# SERVICE BULLETIN

Bulletin No. 7  
Section No. 8

## SUBJECT: IGNITION SYSTEM CHANGE

MODEL: P39

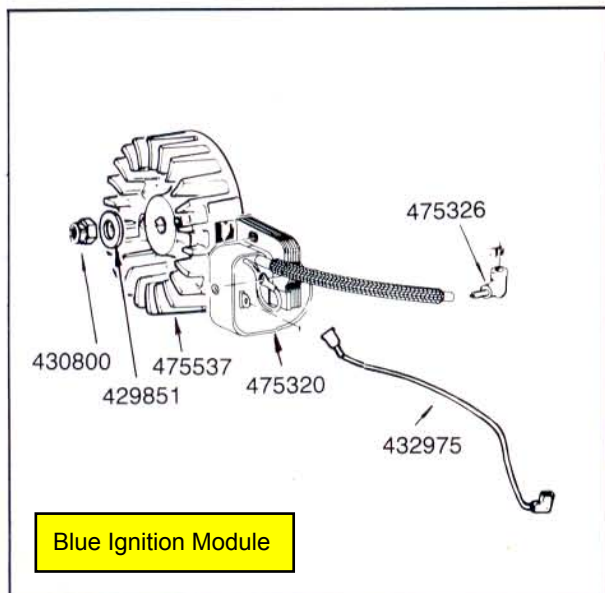
We have **discontinued** the use of the **Wico ignition system** on the P39 and have equipped current units with the **Phelon system** used on models P42, P52 & P62.

Parts which are now changed include the module, flywheel and switch wire. **Please make sure** you order the correct replacement parts.
